IEEE P802.15
Wireless Personal Area Networks

Project	IEEE P802.15 Working Group for Wireless Personal Area Networks (WPANs)	
Title	TG3 Draft D08 to D09 changes	
Date Submitted	[1 December, 2001]	
Source	[James P. K. Gilb] [Mobilian] [12707 High Bluff Dr., Suite 335, San Diego, CA 92130]	Voice: [858-436-2201] Fax: [858-436-2301] E-mail: [gilb@ieee.org]
Re:	[]	
Abstract	[This document contains the additions made by the TG3 technical editor to the draft standard D08 to produce D09.]	
Purpose	[To provide a record of the changes to the TG3 draft standard D08 to make D09.]	
Notice	This document has been prepared to assist the IEEE P802.15. It is offered as a basis for discussion and is not binding on the contributing individual(s) or organization(s). The material in this document is subject to change in form and content after further study. The contributor(s) reserve(s) the right to add, amend or withdraw material contained herein.	
Release	The contributor acknowledges and accepts that this contribution becomes the property of IEEE and may be made publicly available by P802.15.

1. Changes from "Austin Draft Ammendements," document 01/496r2

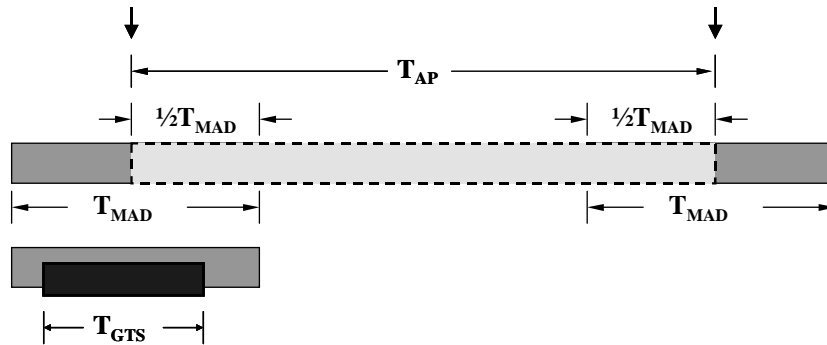
With caveat to add CTRB parameter of desired maximum GTS.

Desired GTS time, i.e. GTS time per allocation period 46

- a) T_{DMG} defines the maximum amount of GTS time per allocation period that a DEV is capable of using. $T_{DMG} > T_{GTS}$ 48
49
- b) If there is unused bandwidth, the extra channel bandwidth can be divided up among DEVs based on what they can actually use. 50
51
- c) Allows channel utilization to be maximized. 52

Ed. action: Change the CTRB to match the figure. The new figure and new text are below:

Figure 14—Illustration of the position of T_{MAD} within T_{AP}

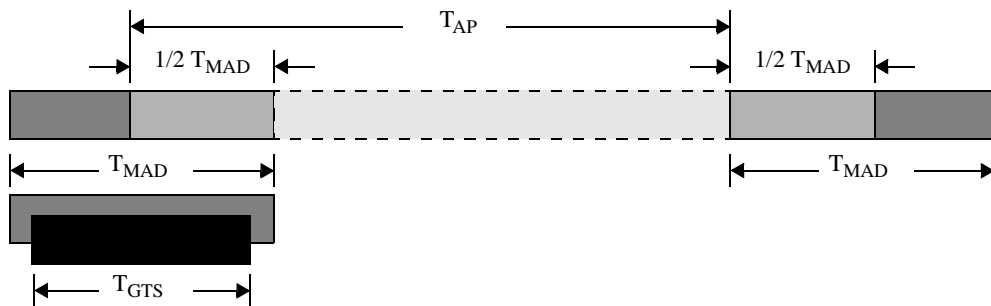
The maximum allocation delay starts before the end of the allocation period, but does not affect the PNC's reference timing of the T_{AP} period. This allows some variability in position of the GTS(s). The DEV determines this time based on the jitter requirements of the data stream that it needs to send. Figure ?? illustrates the position of T_{MAD} within T_{AP} . The T_{GTS} time is the total amount of slot time that needs to be allocated with in the T_{MAD} time centered around the start of the T_{AP} interval.

Figure 15—Possible GTS allocations that meet T_{MAD} requirements

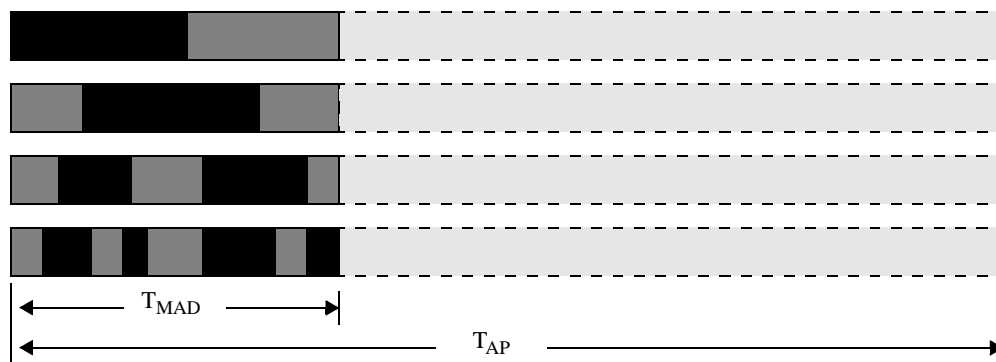
Based on the requirements for T_{MAD} within T_{AP} , the PNC has many possible ways to allocate the GTSs required by the DEV, as illustrated in .

Figure 38—Superframe structure

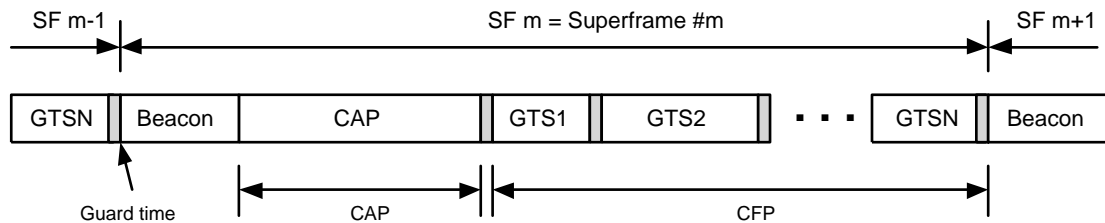
Issue 334, ADH: Figure 49 Superframe structure does not include guardtime

Resolution: Allen will draw up in Visio

Ed. action: New figure added to D09, shown below:
